# EASTERN CORRIDOR SEGMENTS II AND III (PID 86462)

## COMBINED LINWOOD/EASTERN INTERCHANGE & US 50/RED BANK INTERCHANGE FOCUS AREA

### ADVISORY COMMITTEE MEETING NOTES

## MEETING #4 NOTES

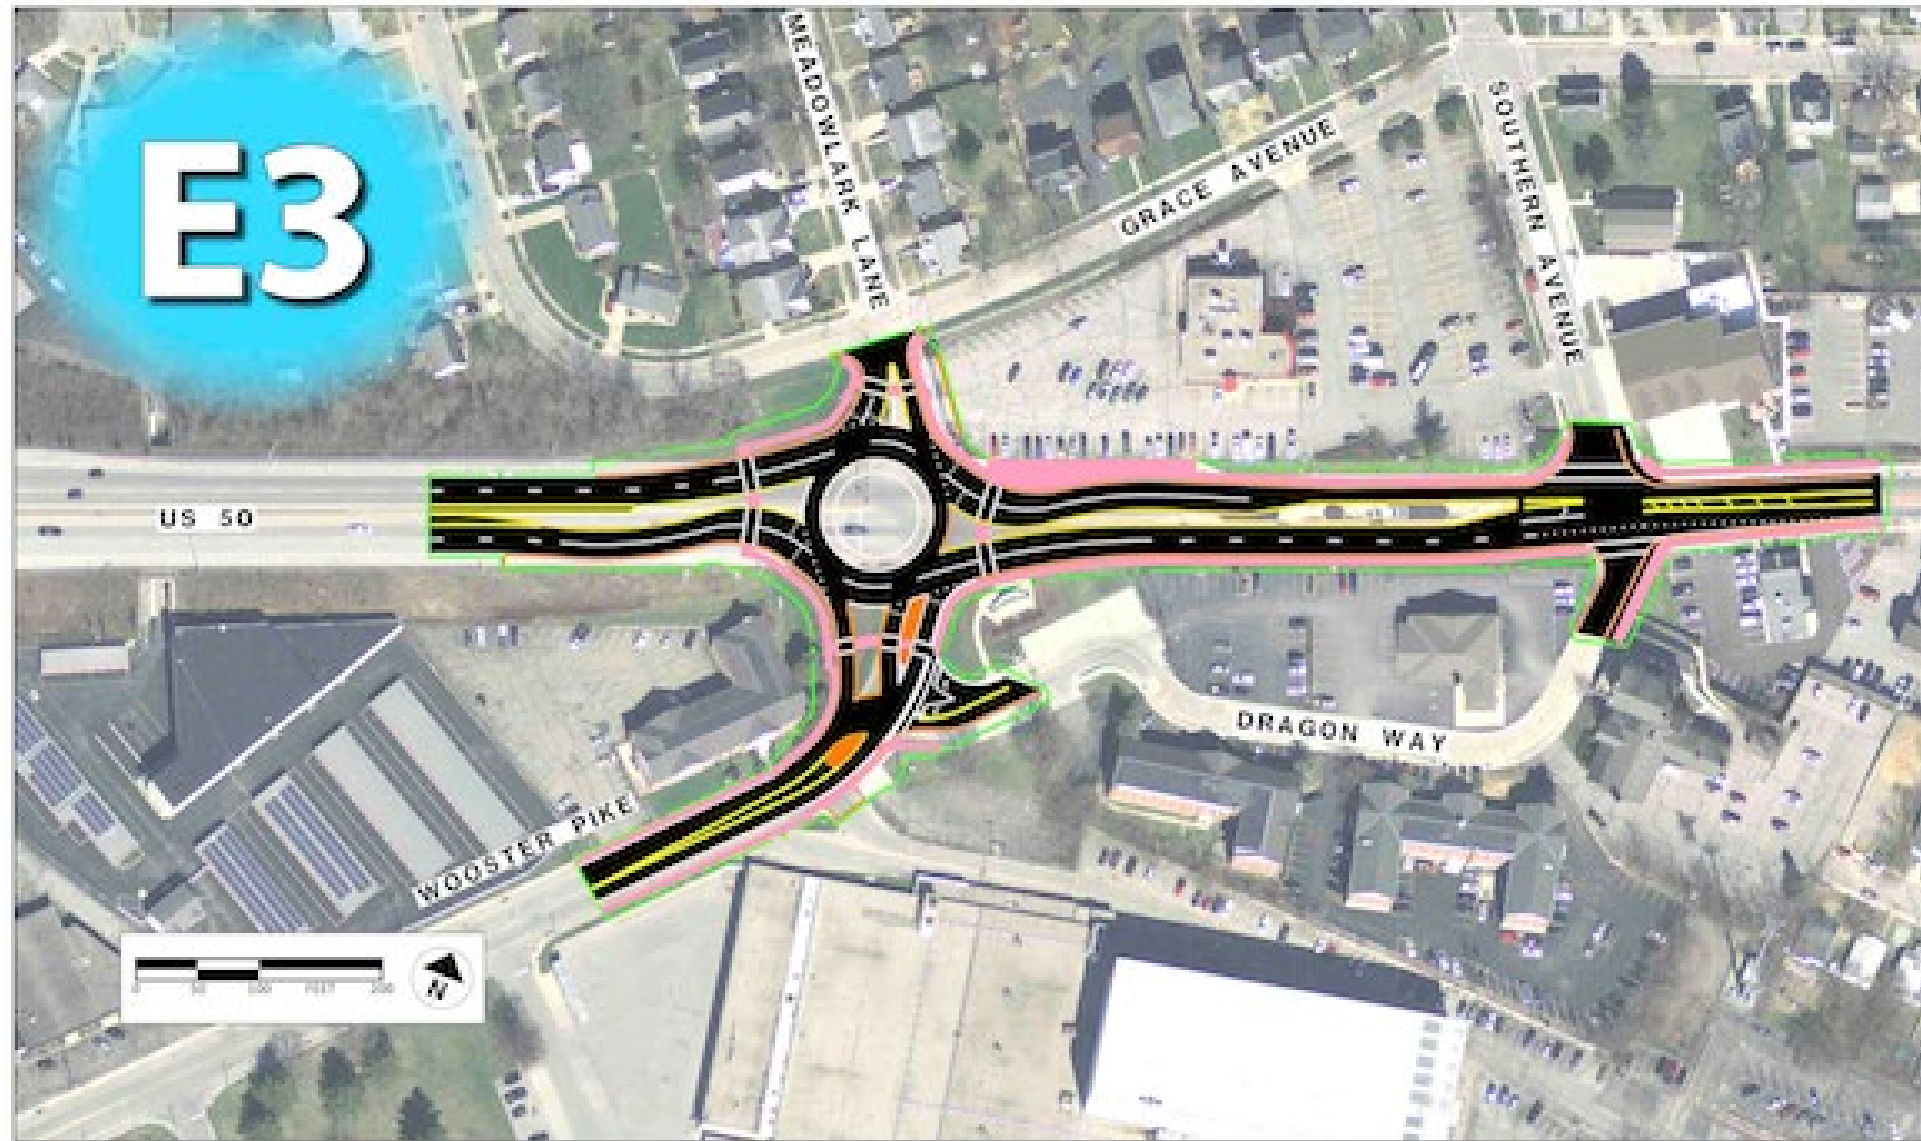
- Verify roundabout shown is drawn to scale and that it will accommodate life safety and semi-truck traffic. Have all other options for this intersection been eliminated? Additional input from Mariemont businesses will be needed to address other potential concerns. The

- The committee discussed whether the traffic signal at Watterson could back drivers up into the roundabout. Traffic simulations show that for 95 percent of queues, this would not be an issue. However, given signal timing adjustments and the fact that closures on Wooster Pike have resulted in more traffic on US 50, these simulations will need to be re-evaluated once Wooster reopens to ensure that is still the case.

- The committee discussed whether it would be simpler to reconfigure the lanes in front of the Mainliner and eliminate the curb bump-outs to allow for two lanes of westbound traffic. This could provide a more immediate solution, with the roundabout phased in later. Long term, however, the roundabout offers other benefits (slower travel speeds, increased safety) and could serve as a gateway to Fairfax.

- This concept was presented as E3 at the October Open House meetings.
- Public comment appears to be favorable toward the roundabout concept (see Public Feedback Ratings Summary, next page).
- There was some discussion about how the roundabout may impact the ability for vehicles to turn onto US 50 from side streets. ODOT/Stantec acknowledged that turning left onto US 50 during peak hours might be challenging.
- The committee agreed that the best approach going forward would be to implement other, lower-cost traffic improvement concepts first and evaluating their effectiveness before pursuing the construction of a roundabout at this intersection.

- Include concept in the Implementation Plan as a medium priority.
- Pursue implementation of signage improvements and adding advanced signal detection improvements first before advancing a roundabout at the Meadowlark/US 50 intersection.

**Roundabout at Wooster and Red Bank**

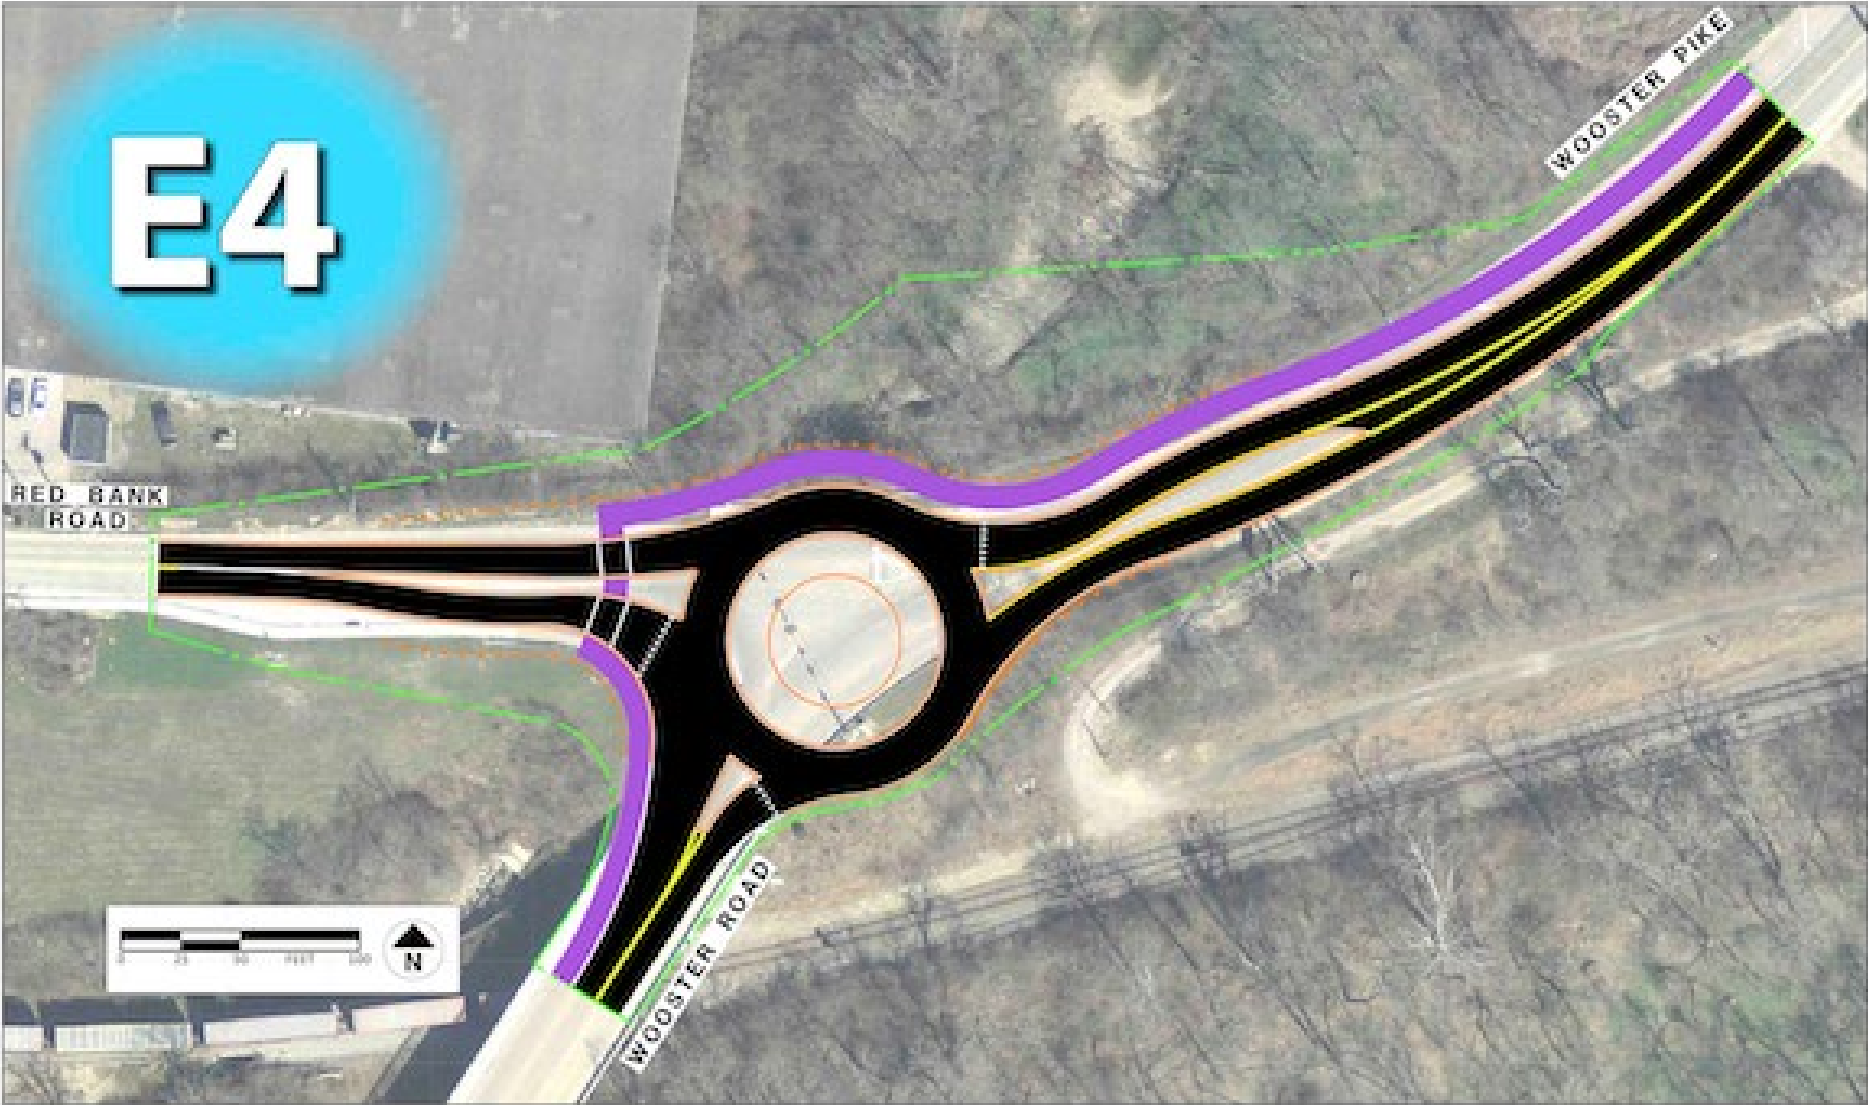
- A roundabout would be designed to comfortably accommodate trucks.
- Would only need to use two lanes instead of three on the bridge, and it would be possible to get a bike lane across the bridge over the railroad without widening the existing bridge.
- Initial analysis indicates:
  - No change in delays during morning peak-hours.
  - A 20 percent increase in delays during evening peak-hours.
- Team will consider how best to incorporate multi-use path connections into this concept.
- No additional comments received following the 5/22 meeting.

- Include in the Implementation Plan as a medium priority.

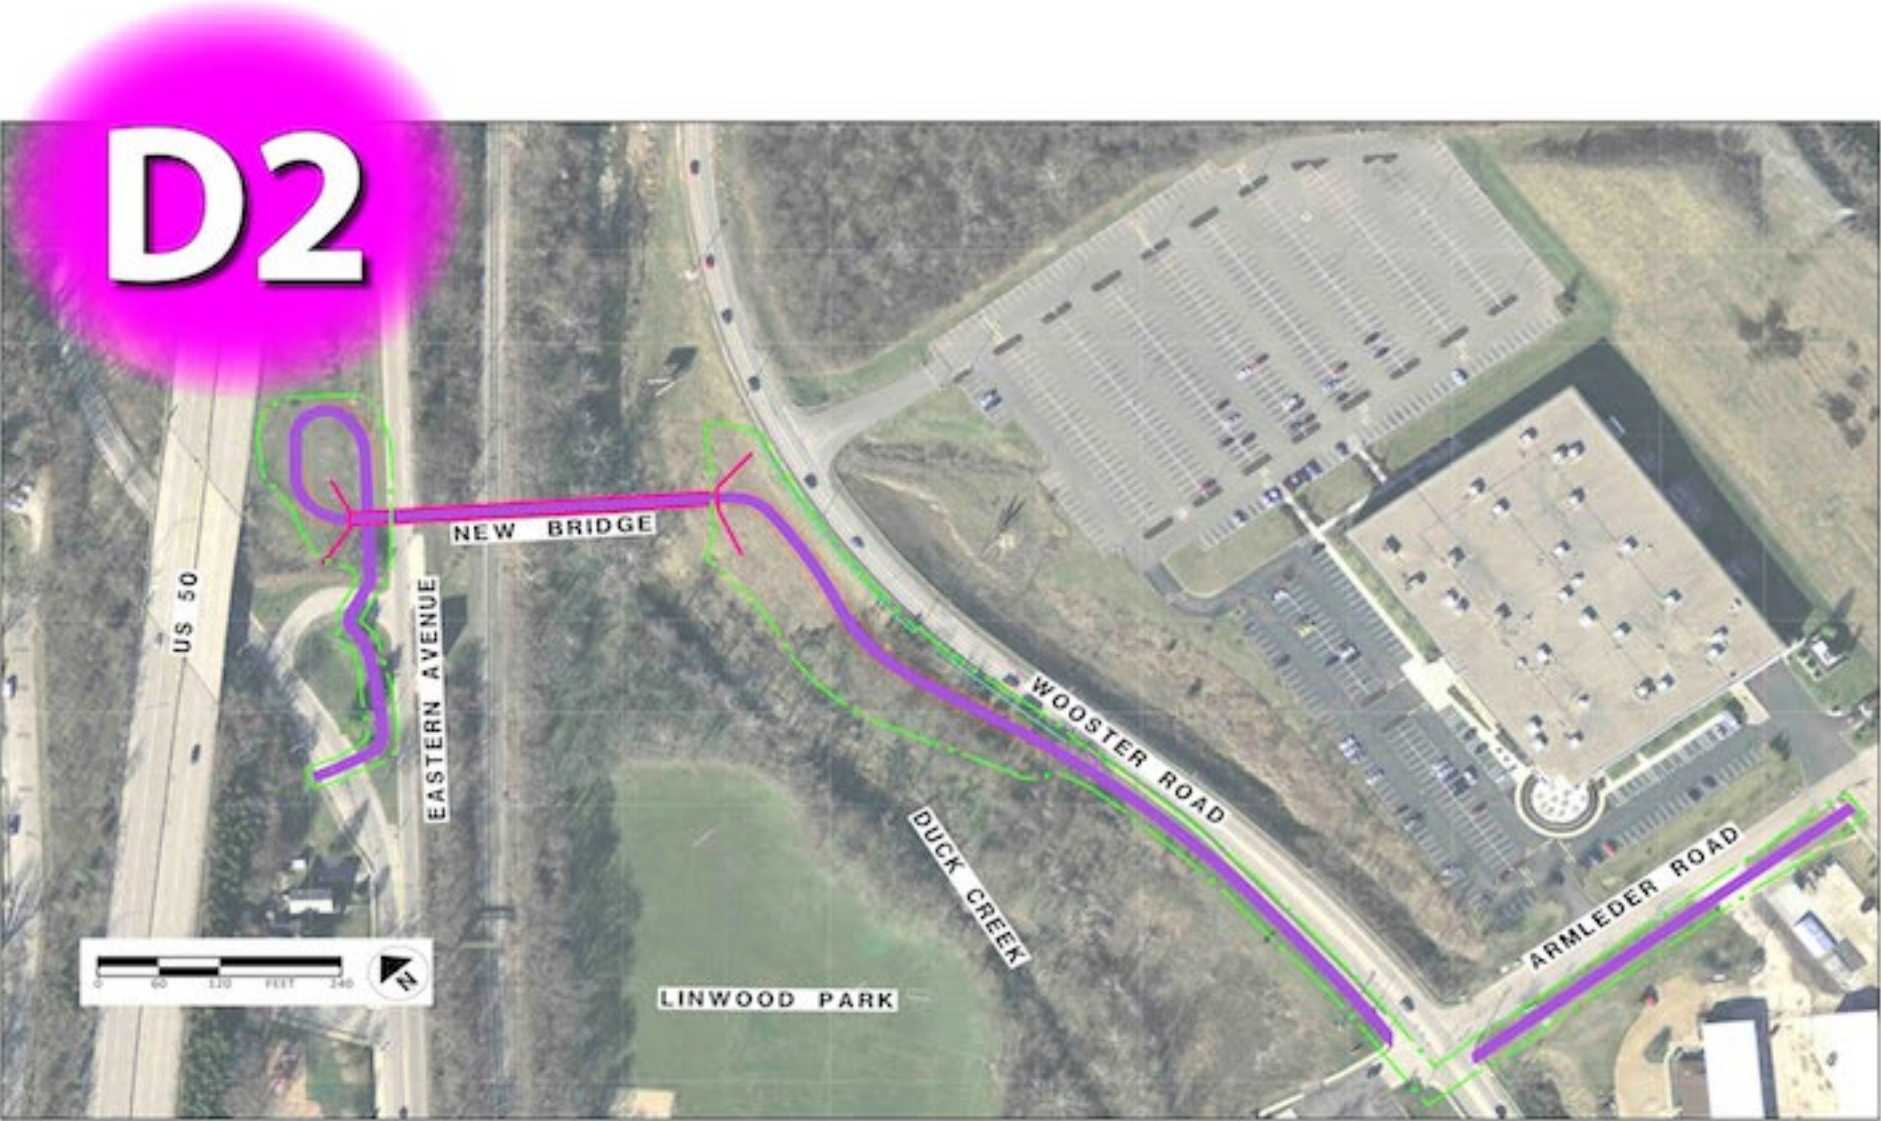
- Public comment on this concept tended toward favorable (see the Public Feedback Ratings Summary, next page).
- ODOT restated the committee’s conclusion from the 9/7 meeting that using the existing pedestrian bridge is not desired because it would need to be retrofitted to accommodate bikes and doing so would be very costly. The bridge also does not cross the creek. Instead, this new concept features a new bridge that spans across Eastern Avenue, the railroad and the creek.

- The City of Cincinnati expressed concern that this new concept does not connect local neighborhoods.
  - It does provide a connection between the Linwood neighborhood and Armleder Park, but not communities north of Eastern Avenue.

- Include in the Implementation Plan as component of concept BIKE-2a (E5) as a medium priority.

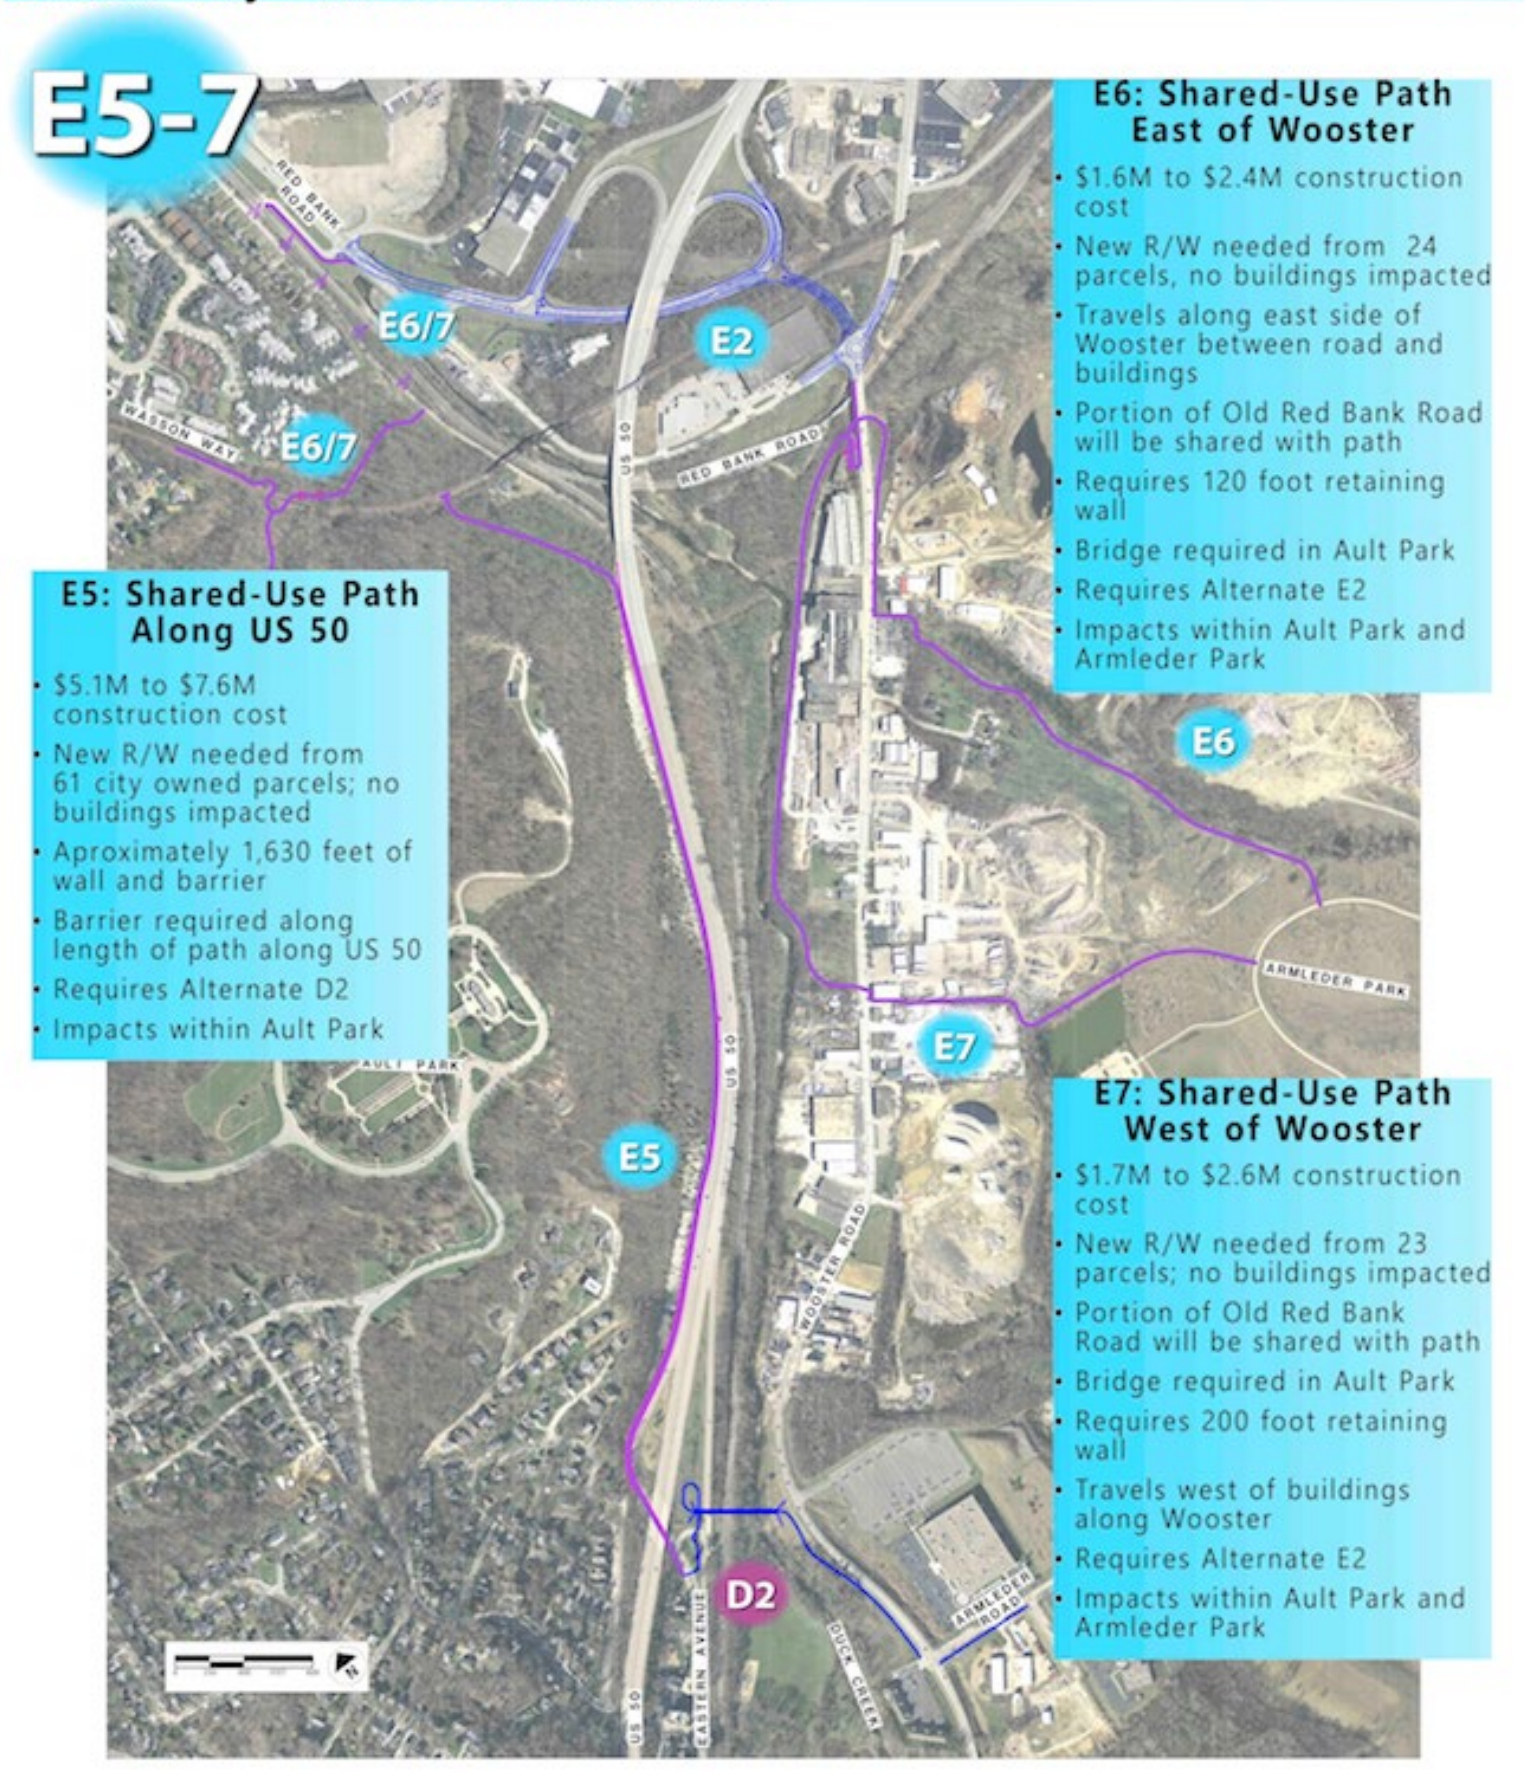
- This concept requires construction of a new bridge crossing from Eastern Avenue to Wooster Road. The bridge would be located immediately east of Linwood Park.
- A shared-use path located next to US 50 would need to be separated by a physical barrier; concrete barriers are proposed. Installing concrete barriers would not impact the hillside or shoulder along US 50, but would require modification of the city gateway.
  - One Committee member expressed concern that cyclists would be traveling a long way without an option to exit the path. Another

- Include in the Implementation Plan as a medium priority, including BIKE-2a (E5) and BIKE-1a (D2) to fully connect Wasson Way Trail to Armleder Park.
- Consider connecting Murray Trail spur.
